**RE: The Preserve (DD9835)**

WALKSacramento has reviewed the second project routing for The Preserve (DD9835) and we offer the following comments.

Figure 1 Parcel I Paseo

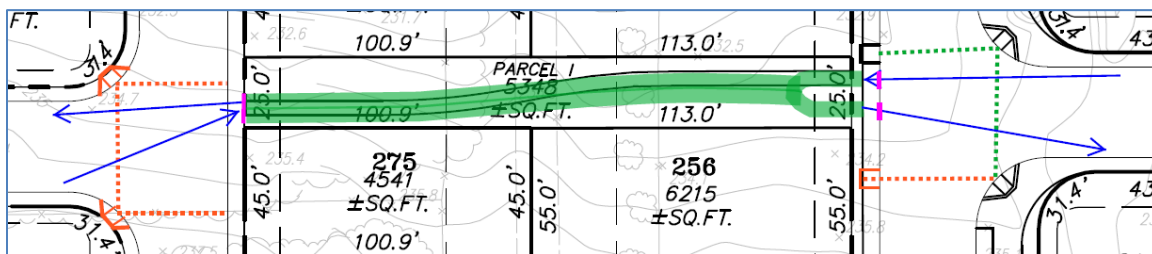
The paseo sidewalks that meander through mid-block Parcel I and Parcel N at the end of the Street 'E' cul-de-sac appear to be 5' wide. Regardless of the presence or absence of the multiuse 10' sidewalk, these two short sidewalk segments will likely see bicycle use so the 5' width will be too narrow.

Close attention should be given to the alignment, location and relationship of crosswalk curb ramps, bicycle movement on streets, and bicycle ramps. Note that Parcel I is offset from the centerlines of both Street 'E' to the west and Street 'G' to the east, confounding bicycle and pedestrian travel paths. Also, the paseo sidewalk at the west end of Parcel I is close to where a curb ramp for the north-leg crosswalk will need to be, preventing the splitting of the sidewalk near the street sidewalk. In the two figures below, solid green represents sidewalks, dashed green represents crosswalks, solid and dashed orange represents missing curb ramps and crosswalks, solid blue represents bicycle travel paths, and solid magenta represents missing bicycle ramps.

4. We recommend increasing the width of the sidewalks in Parcels I and N to 8' or 10', depending on expected bicycle usage, bifurcating the sidewalk at each end to slow cyclists crossing the street sidewalks and transitioning between the street and the paseo sidewalk, and shifting Parcel I south about 20'.
